PROJECT: NEW ADMINISTRATIVE BUILDING FOR THE NATIONAL ASSEMBLY OF CAMBODIA

WORK PACKAGE: MAIN CONTRACT WORK

SUBJECT: CLARIFICATION OF BIDDING DOCUMENTS NO.06

NA-AR-7017

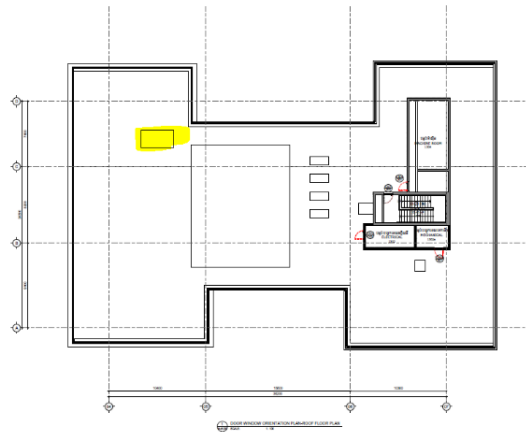
Is there any access opening to maintenance at doghouse?

We don't need access opening to maintenance the doghouse.

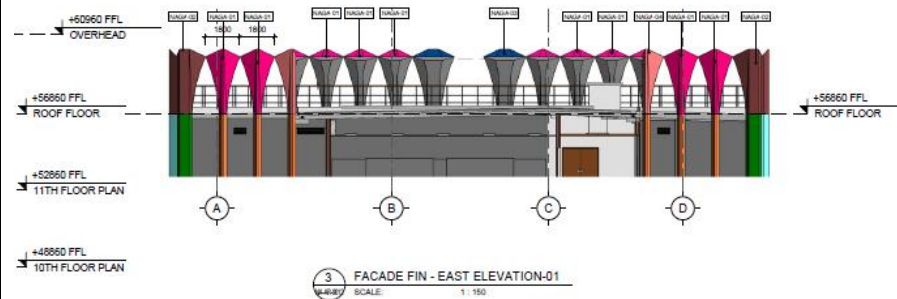
Please provide full view façade fin – East Elevation 01

Please find attached file in provided downloadable link below for the full view of façade fin – east elevation as requested.

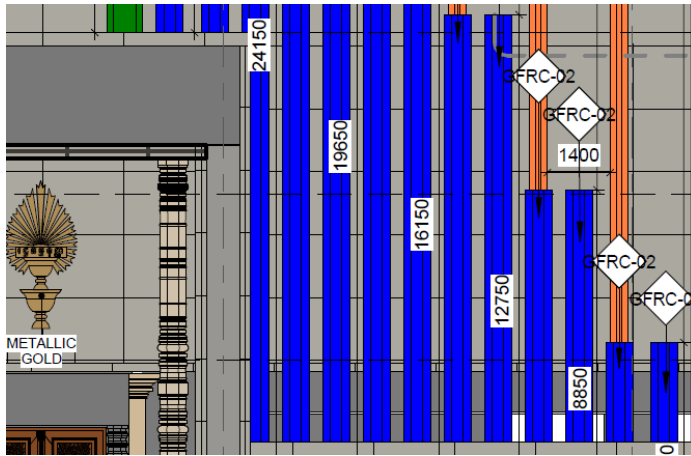
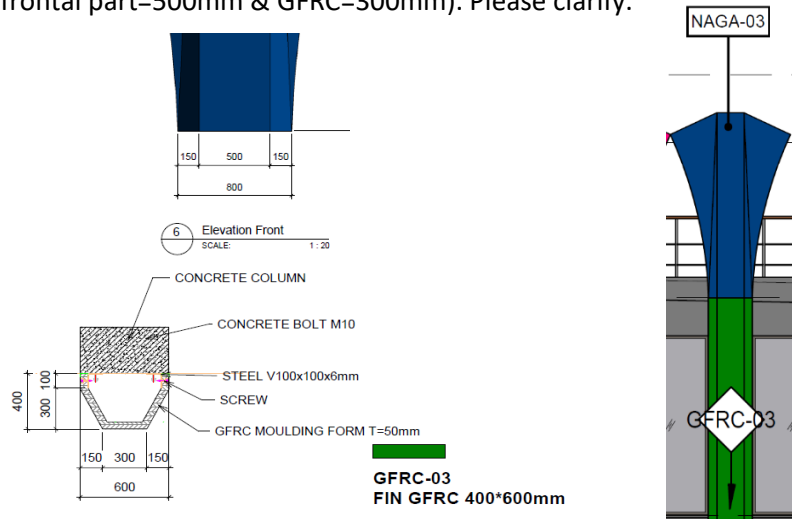
Please provide detail connection GFRC-01 to GFRC-02 and detail cover of GFRC-02

For the connection between GFRC-01 and GFRC-02, Contractor/bidder can propose the detail and prevent the leakage within the fins.

Please find attached file in provided downloadable link below for the reference sketch.

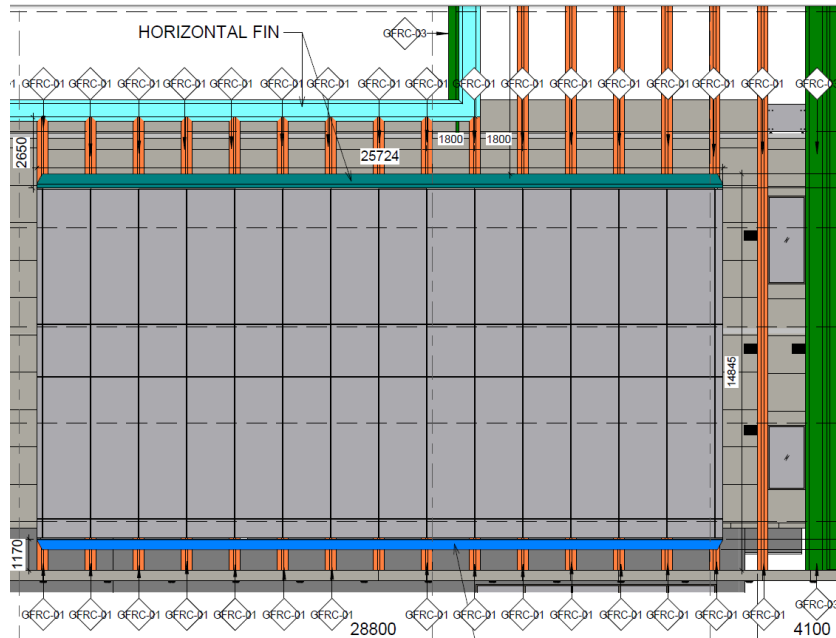
Please provide typical joint detail between GFR-01 & Horizontal Fin.

Contractor shall propose the detail as per technical.

Please find attached file in provided downloadable link below for the reference sketch.
